NEENAH PLAN COMMISSION

RE: Site Plan Review – 1712 Dixie Road – Gunderson Uniform and Linen

RE: Site Plan #20-25 - 1712 Dixie Road - Dry Cleaners Site Plan - Major Review () Status Conditional

Plan Review Comments

DRAINAGE & GRADING PLAN

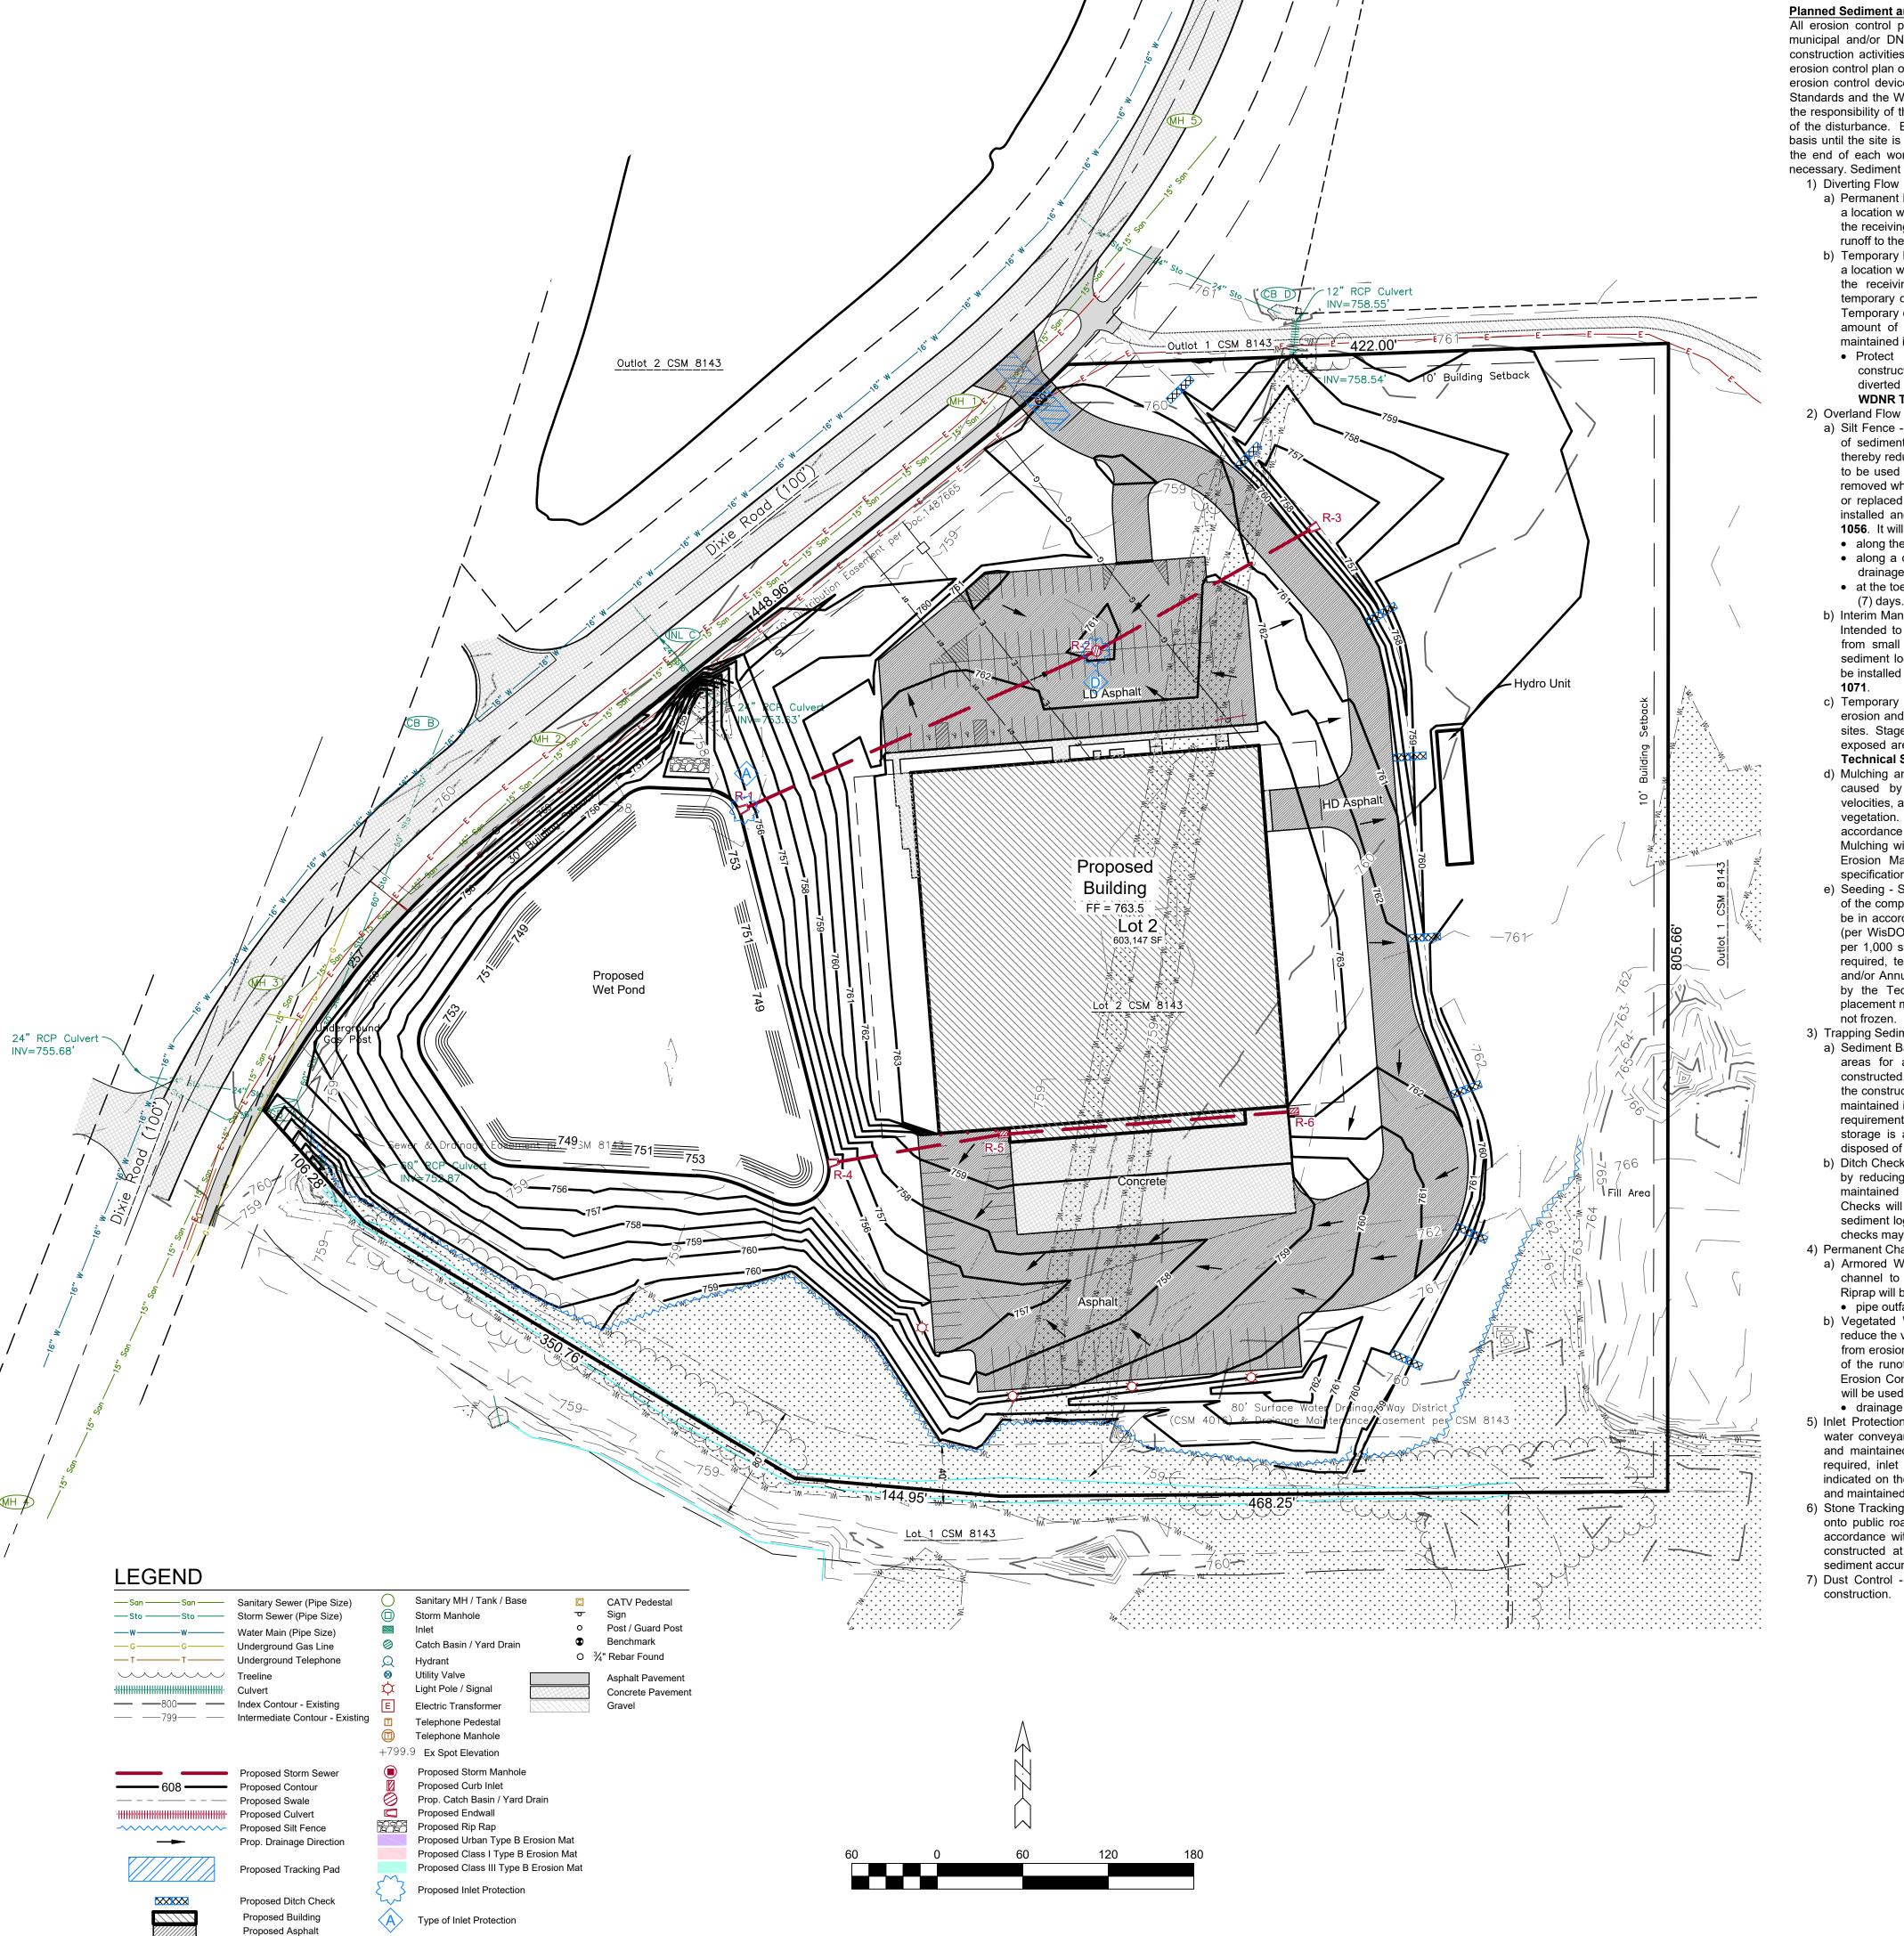
Grading Along Trail & Pond - Areas along the trail next to the pond shall have at minimum a 5 foot flat recovery area for safety. Pond side slopes in this area should be minimized with a maximum slope of 4:1.

EROSION & SEDIMENT

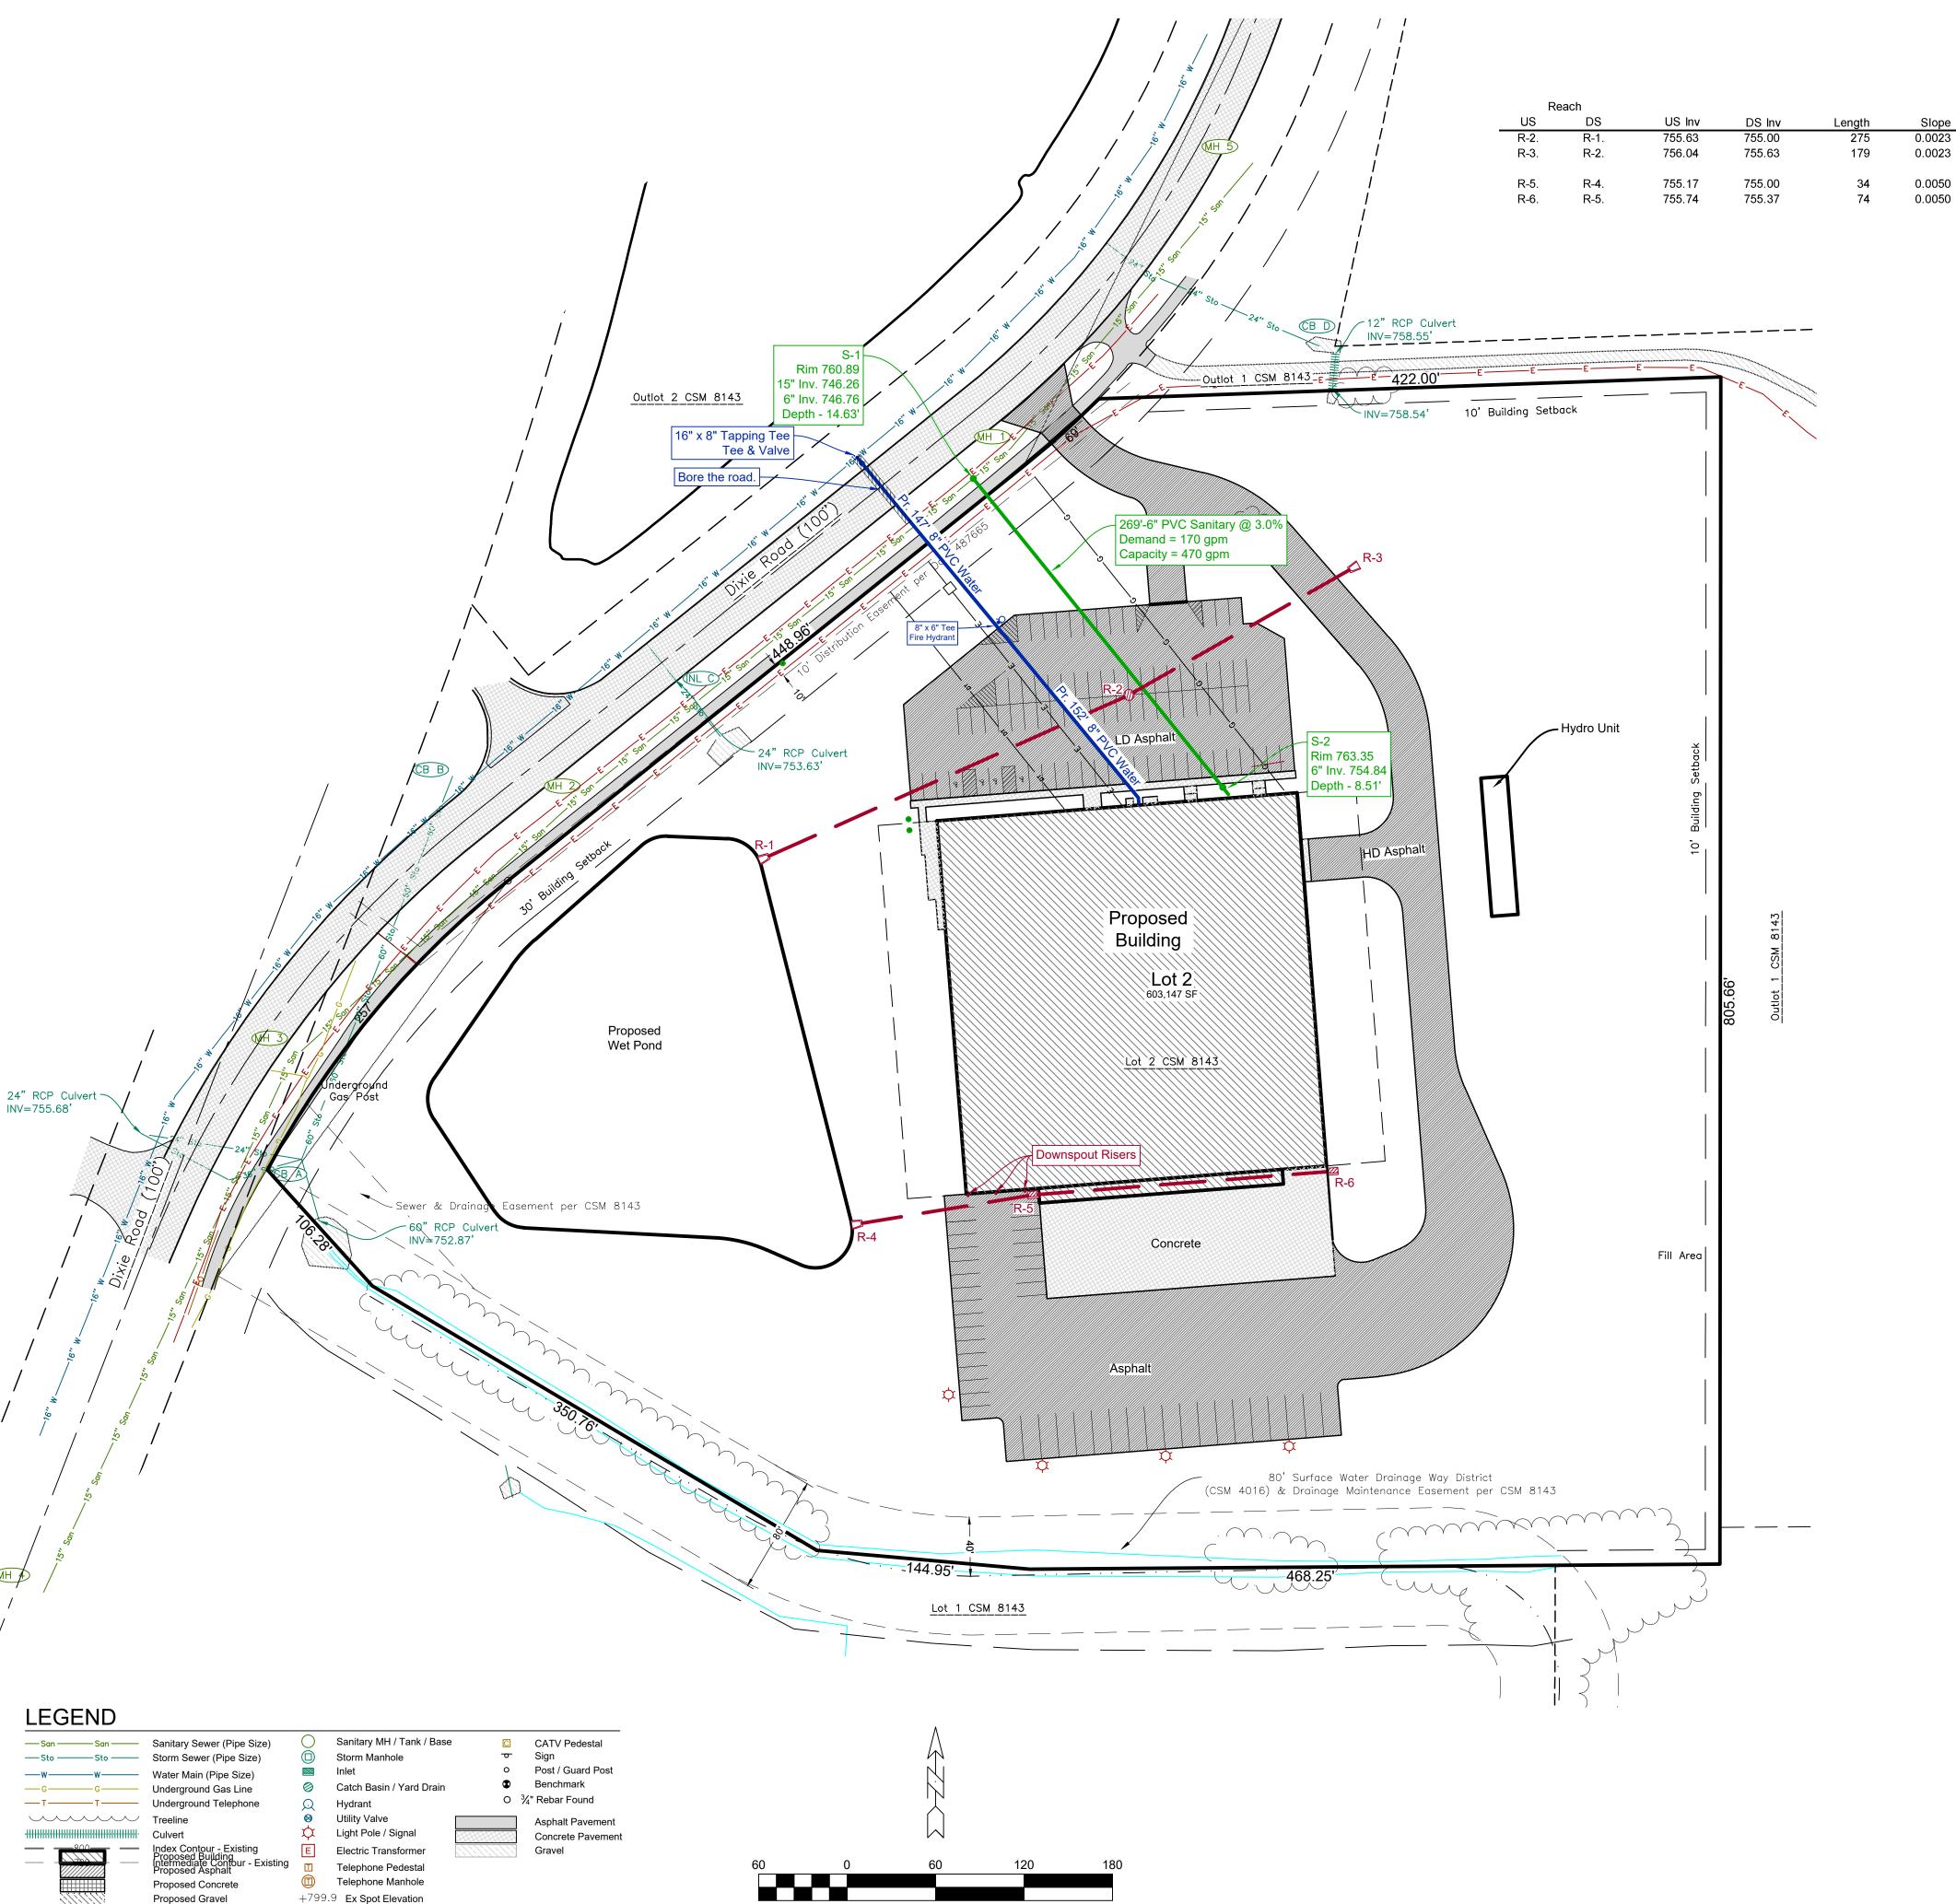
Erosion Control - Add inlet protection to street inlets north of construction outlet and Inlet C.

- Add ditch check north of pond discharge pipe.
